# UNITED STATES PATENT AND TRADEMARK OFFICE

APPLICATION NO.	FILING DATE	FIRST NAMED INVENTOR	ATTORNEY DOCKET NO.	CONFIRMATION NO.
10/707,184	11/25/2003	Peter T. Kazlas	H-360	1183
26245 7590 12/28/2007 DAVID J COLE E INK CORPORATION 733 CONCORD AVE CAMBRIDGE, MA 02138-1002			EXAMINER NGUYEN, KHIEM D	
			ART UNIT 2823	PAPER NUMBER
			MAIL DATE 12/28/2007	DELIVERY MODE PAPER

## Office Action Summary

## **DETAILED ACTION**

Figure 3

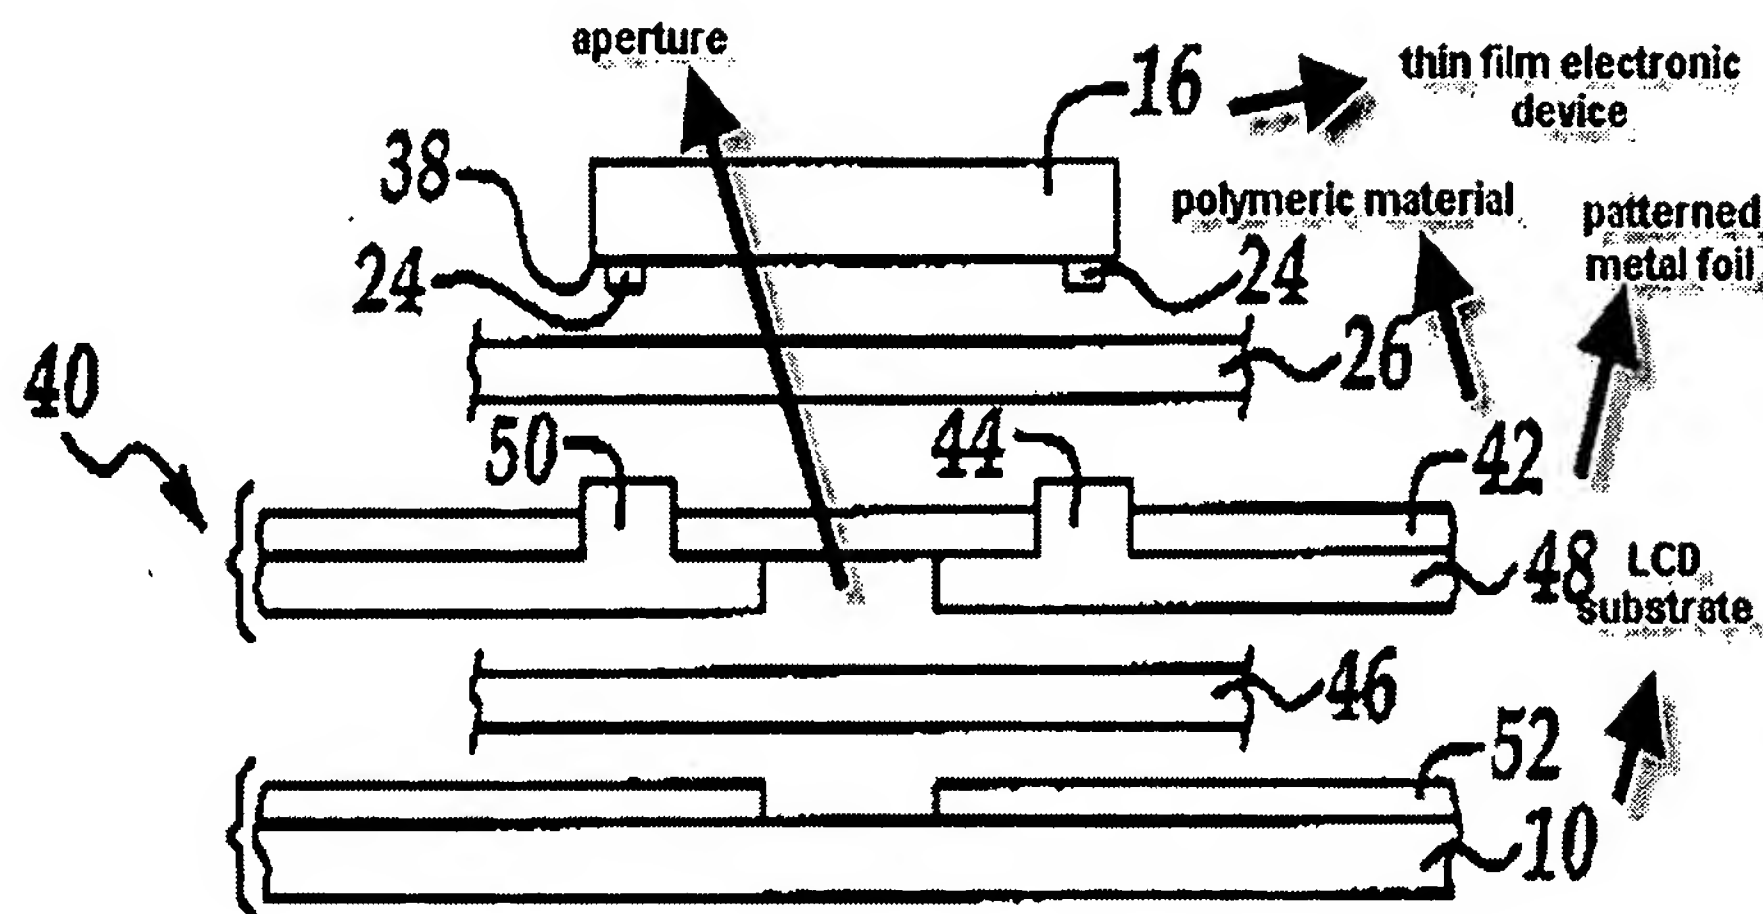
In re claim 12, Yang et al. disclose a backplane for use in an electro-optic display, the backplane comprising a metal foil 48 coated on at least one side with an insulating polymeric material 42 (see col. 6, lines 11-33) and having an thin film electronic device provided on the insulating polymeric material 42, (see col. 6, lines 34-41 and FIGS. 3-4, for example), the backplane further comprising at least one conductive via 44, 50 extending through the polymeric material 42 and electrically connecting at

least one of the thin film electronic device 16 to the metal foil 48 (see col. 6, lines 28-64 and FIGS. 3-5, for example).

However, Yang et al. is silent about a plurality of thin film electronic devices provided on the insulating polymeric material.

Takabayashi et al. disclose a backplane for use in an electro-optic display, the backplane comprising a plurality of thin film electronic devices 2 provided on the liquid crystal display (LCD) substrate 50 (see col. 8, lines 42-59 and FIG. 5B, for example).

As Takabayashi et al. disclose, one of ordinary skill in the art would have been motivated to provide a plurality of thin film electronic devices on the insulating polymeric material in order to obtain a multi-element module and a production process capable of suppressing an increase in production costs and preventing a lowering in production yield (see col. 3, line 65 to col. 4, line 7 of Takabayashi et al.).

Therefore, it would have been obvious to one having ordinary skill in the art at the time of applicant(s) claimed invention was made to modify Yang et al. reference with a

plurality of thin film electronic devices provided on the insulating polymeric material as taught by Takabayashi et al. in order to obtain a multi-element module and a production process capable of suppressing an increase in production costs and preventing a lowering in production yield (see col. 3, line 65 to col. 4, line 7 of Takabayashi et al.).

**Figure 3**

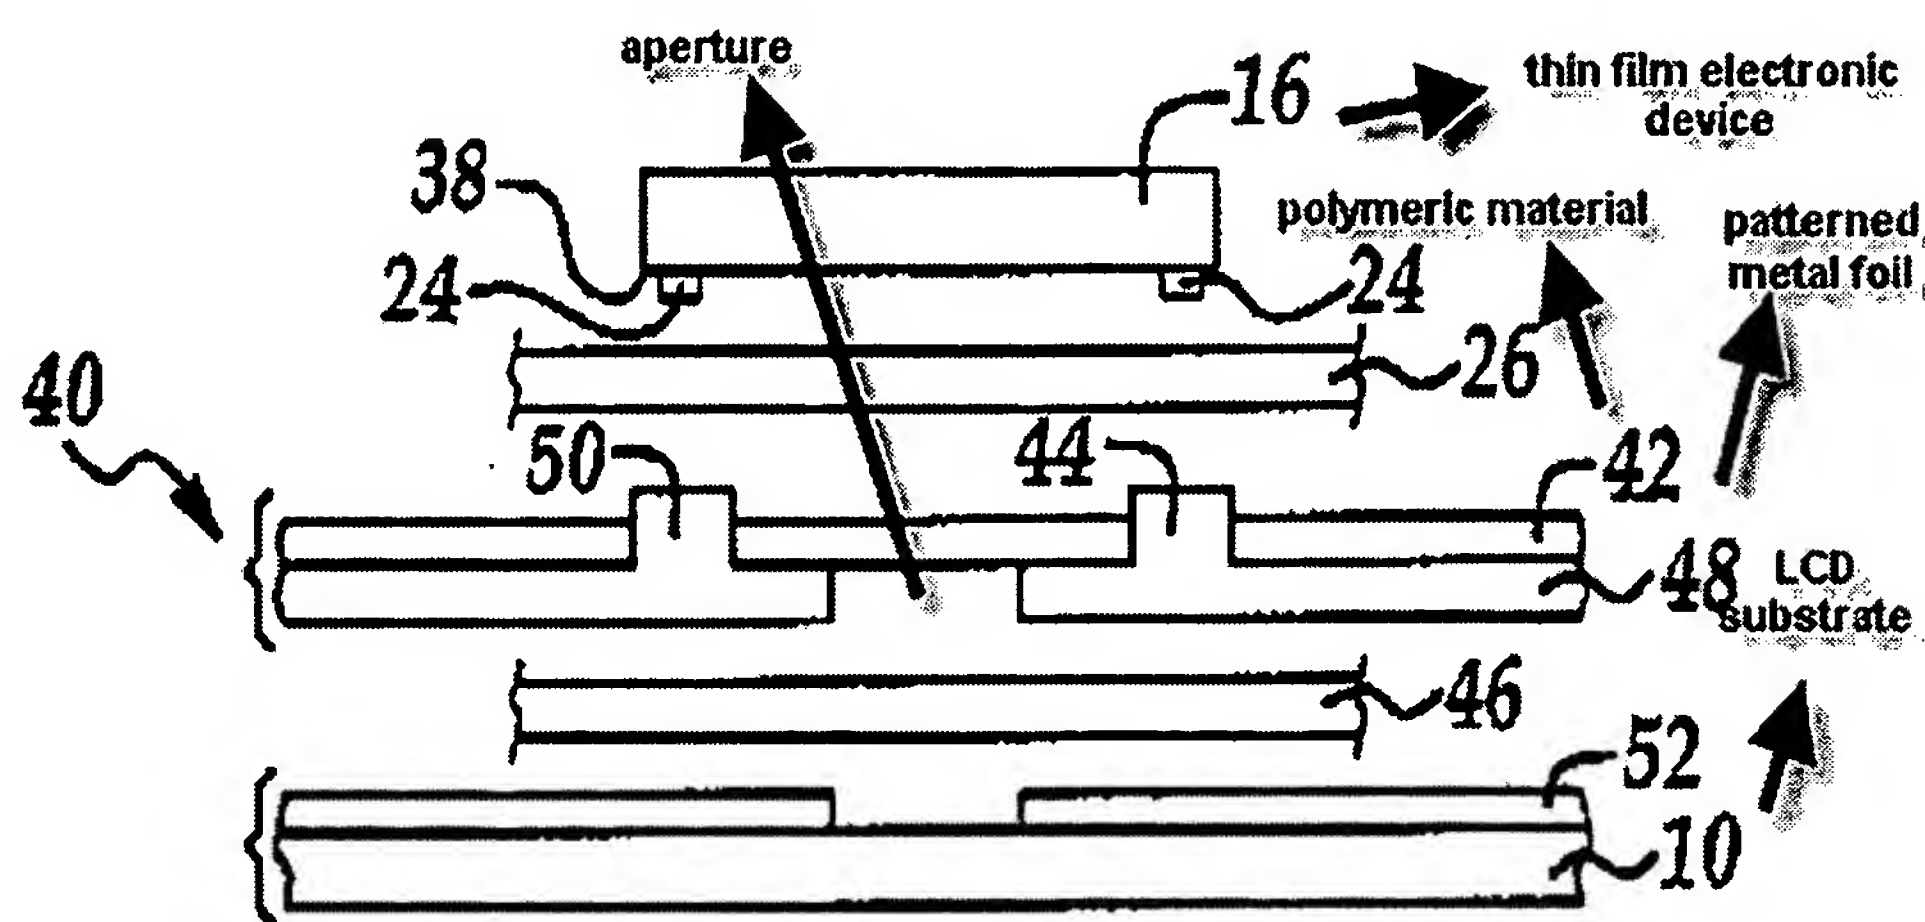
In re claim 24, Yang et al. disclose an electro-optic display having a metal substrate 48, the display having a central portion comprising an electro-optic material and means for writing an image on the electro-optic material (see col. 6, lines 11-13), and a peripheral portion extending around at least part of the periphery of the central portion, the peripheral portion having an aperture extending through the metal substrate 48, by

means of which apertures the electro-optic display may be stitched to a flexible medium (see col. 6, lines 16-64 and FIGS. 3-5, for example).

However, Yang et al. is silent about a plurality of apertures extending through the metal substrate.

Takabayashi et al. disclose a backplane for use in an electro-optic display, the backplane comprising a plurality of thin film electronic devices 2 provided on the liquid crystal display (LCD) substrate 50 (see col. 8, lines 42-59 and FIG. 5B).

As Takabayashi et al. disclose, one of ordinary skill in the art would have been motivated to provide a plurality of thin film electronic devices on the insulating polymeric material in order to obtain a multi-element module and a production process capable of suppressing an increase in production costs and preventing a lowering in production yield (see col. 3, line 65 to col. 4, line 7 of Takabayashi et al.).

In view of the above, since Yang et al. in combination with Takabayashi et al. disclose that a plurality of thin film electronic devices capable of provided on the LCD

substrate. It is obvious that the peripheral portion also including a plurality of apertures extending through the metal substrate.

Therefore, it would have been obvious to one having ordinary skill in the art at the time of applicant(s) claimed invention was made to modify Yang et al. reference with a plurality of thin film electronic devices provided on LCD substrate as taught by Takabayashi et al. and the peripheral portion having a plurality of apertures extending through the metal substrate in order to obtain a multi-element module and a production process capable of suppressing an increase in production costs and preventing a lowering in production yield (see col. 3, line 65 to col. 4, line 7 of Takabayashi et al.).
